Subject: Submission DA2021/1469 23 Loch St, Freshwater.

Report Subject: Proposed redevelopment of 23 Loch Street
Stormwater management Design.

Report No. 2021/X-28

Prepared by: James Olive, Hydraulic Systems Design Manager.

JCL reference document No.3

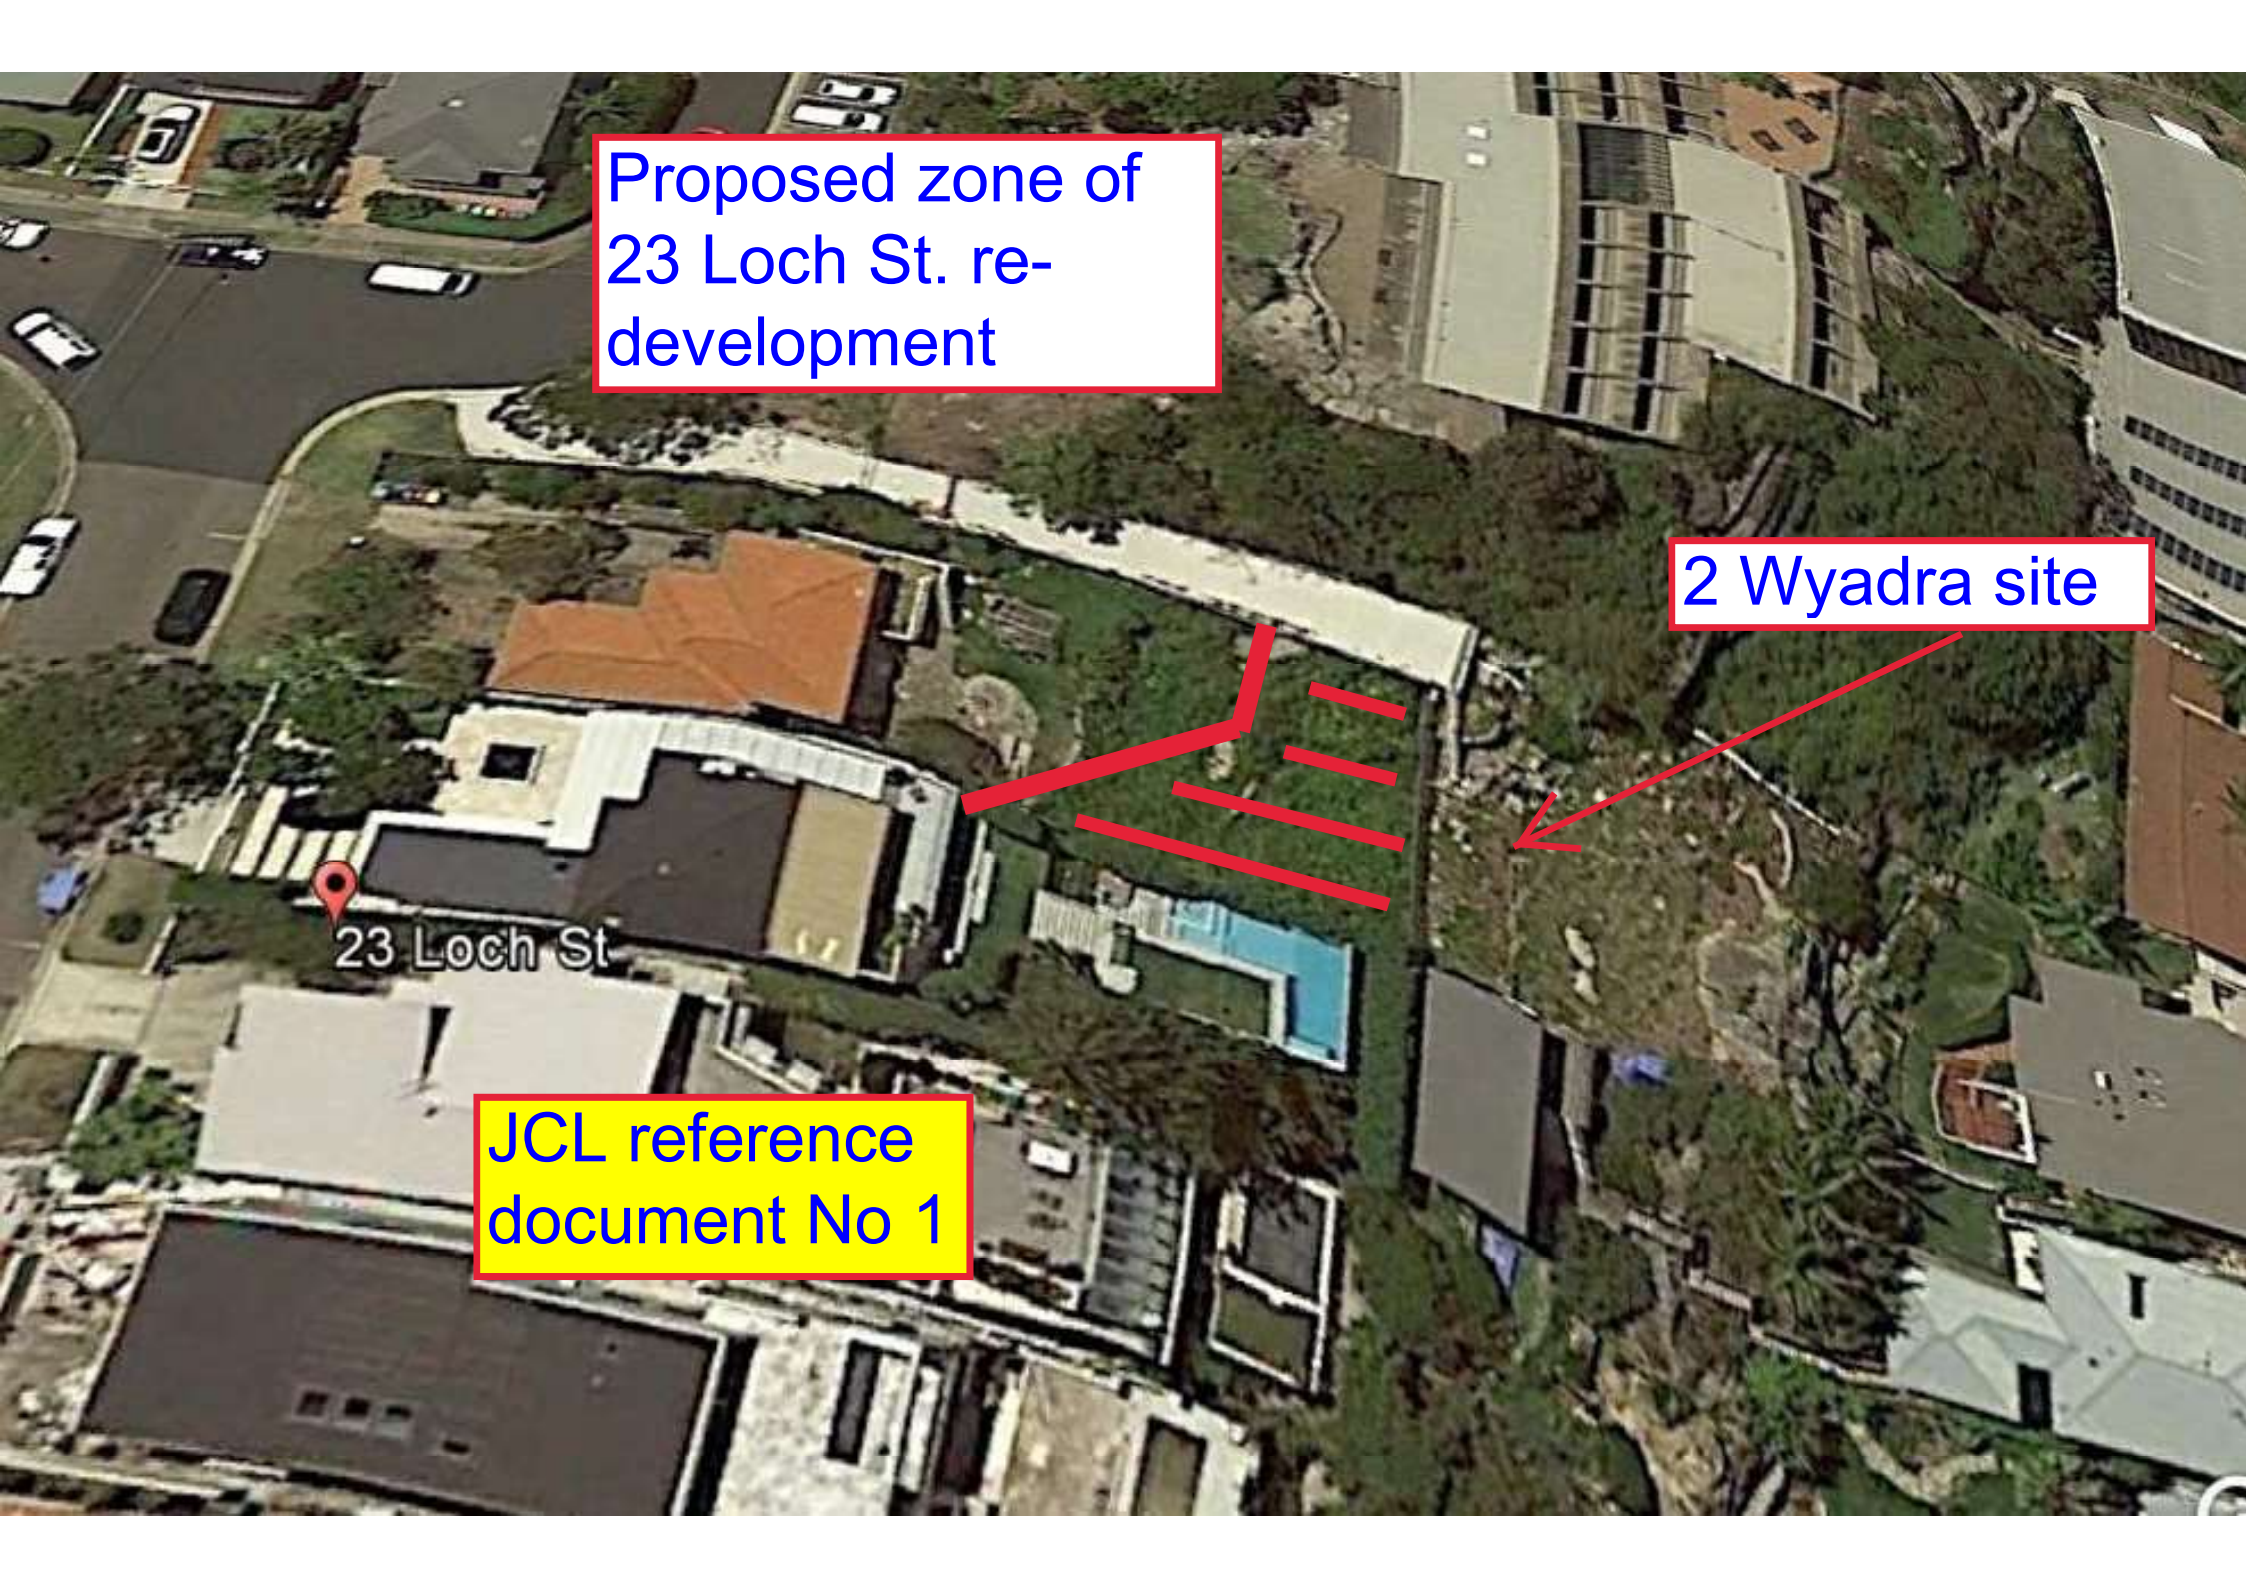
As shown on JCL reference document No. 3 existing surface levels question whether the storm discharge from No. 25 Loch Street building roof catchment currently is discharged to Loch Street or to existing soil profile absorption trenches in the Eastern Zone, rear of block, which with the redevelopment of No. 23 Loch Street will be made redundant.

JCL recommend that the current method of storm water runoff from No. 25 Loch Street be confirmed by site investigation.

? On existing disposal of Storm Water runoff from Existing building roof catchment, is there current disposal by infiltration into soil profile of roof and hard surface storm runoff.

SCALE		JOB No	
1:100 @ A1 / 1:200 @ A3		19/152	
DISCIPLINE	DRAWING No	REVISION	
HYD	H-DA-02	C

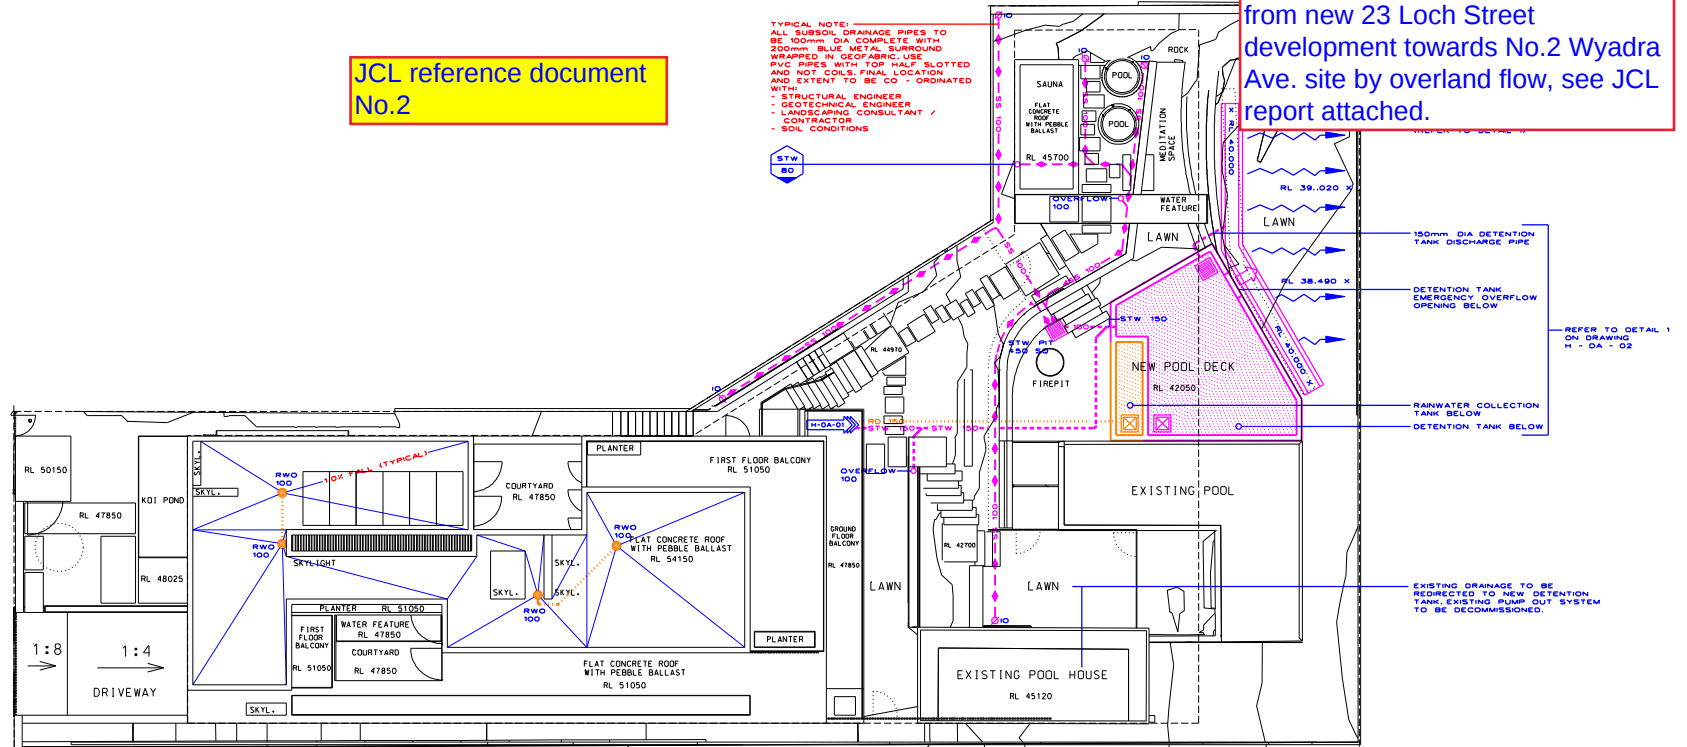
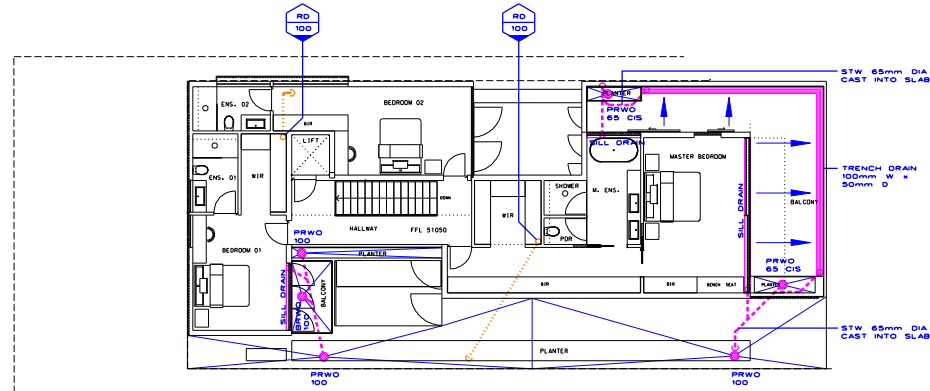
JCL have been requested to provide comment on the proposal to discharge storm runoff from No. 23 Loch Street, see attached ITM Design drawing H-DA-02, including JCL comments, marked as JCL Reference Document No.2.

As shown on the JCL Reference Document No.2 ITM Design proposal confirms the direct disposal of storm runoff from the redevelopment of 23 Loch Street onto No. 2 Wyadra Avenue.

JCL are of the opinion that the proposal of On-Site Stormwater management as shown on ITM Design drawings is not compliant with the clear direction and expectations of the Northern Beaches Council Water Management for Development Policy as listed in section 5.0, see attached policy extract.

The NBC policy in clause 5.5 Stormwater drainage from Low Level Properties clearly states in 5.5.1.1.2 the performance requirements for Onsite Stormwater Absorption systems and 5.5.1.1.3 for disposal by Level Spreader, it is the JCL opinion that the proposed design is non-compliant with these design controls.

Proposal is to direct storm flows from new 23 Loch Street development towards No.2 Wyadra Ave. site by overland flow, see JCL report attached.
